Addendum No. 3

City of Coquitlam

RFP No. 24-066

Construction Services at Miller Park

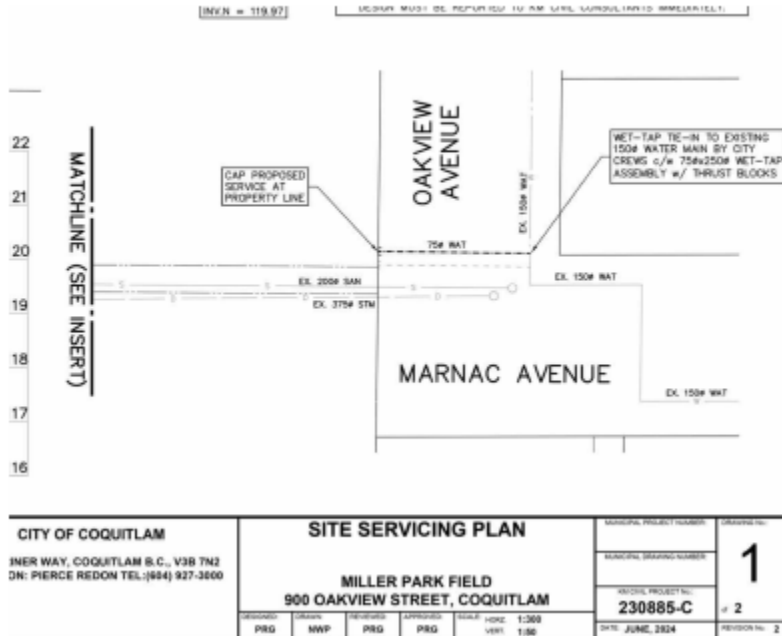
Q10. What type of pavement inside the dugouts? Asphalt or Concrete?

A10. Concrete, see Appendix B detail D1.

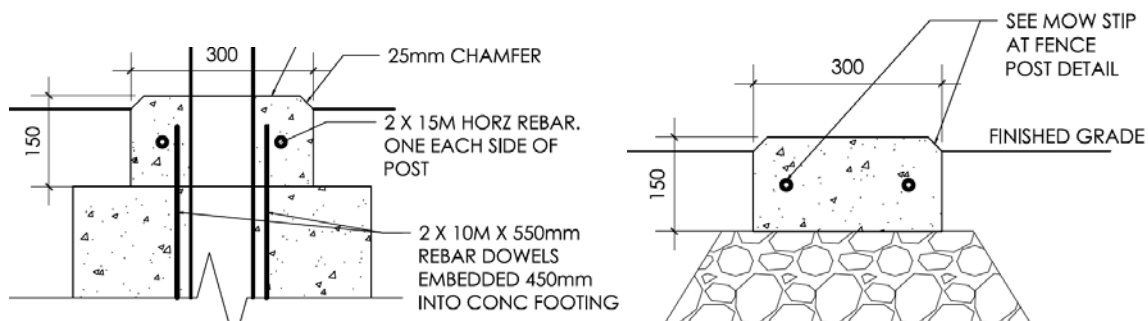
Q14. If look at the backstop details D4 and D5, above the concrete footing, it is a squared concrete top/block 0.3mx0.3m *0.15m thick, it is not a concrete strip, how does that work? Or this require the fence company to make it to shape when install fence post?

A14. The mow strip is intended to be a 300 mm wide concrete surface along all sections of fence. Wherever a concrete foundation underlays the mow strip rebar dowels are required. For all other areas it shall be installed on aggregate base. The following details will be incorporated in the IFC set.

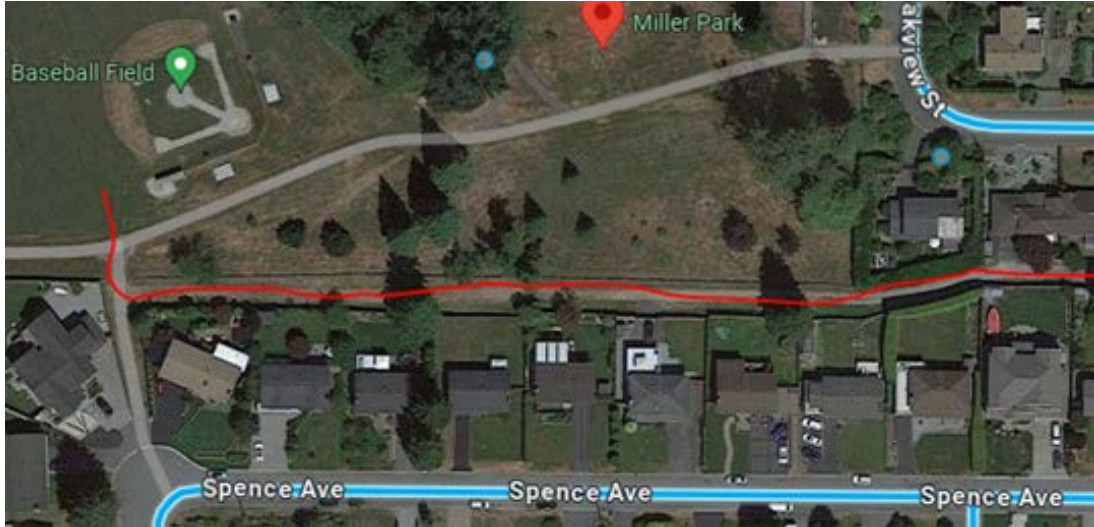
Q16. Can we use this maintenance road for trucking in material and out for disposal?

A16. Utility Right of Way is not an approved access route.

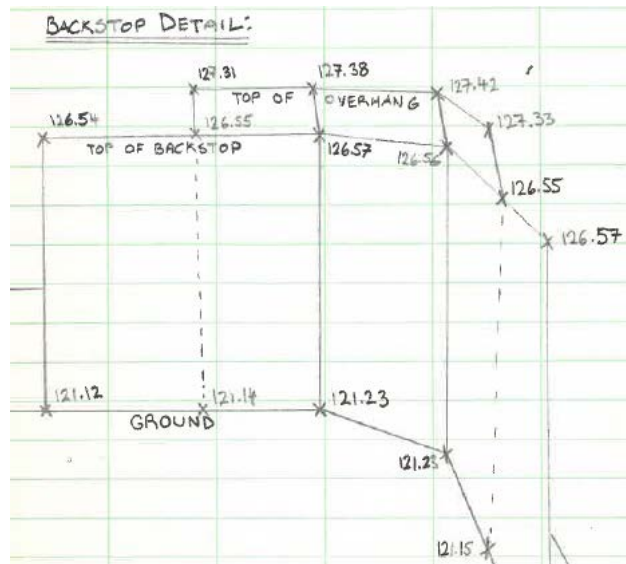
Q17. Could you please provide a more detailed elevation drawing of the back stop. It would be helpful to see how height continues and steps down.

A17. The proposed backstop is intended to match existing. The City will prepare a detail for IFC, but for the purposes of this Addendum the following sketch illustrates the design intent:

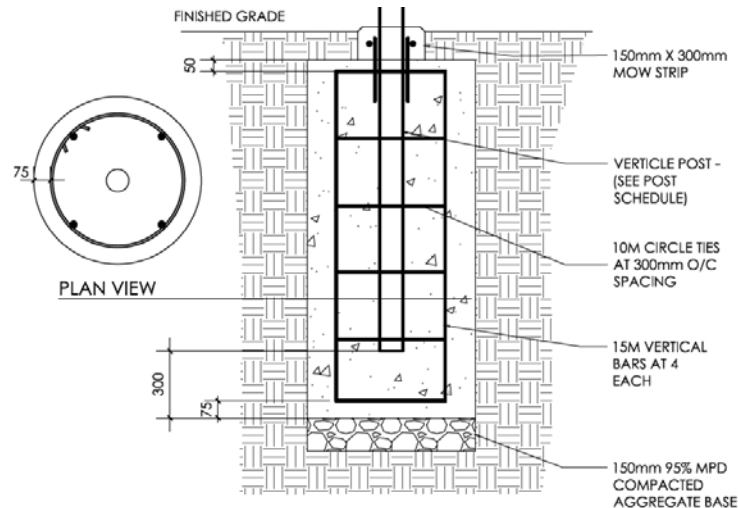
Q18. Could you provide a footing detail for the backstop & 1.2m high chain link fence.

A18. Backstops: 600mmØ x 1800mm depth [min. 32MPa & reinforced, see below TYP.]

Dugouts: 300mmØ x 900mm depth [min. 32MPa & reinforced, see below TYP.]

Sidelines (1.2m ht.): 300mmØ x 600mm depth [min. 20MPa, no rebar]
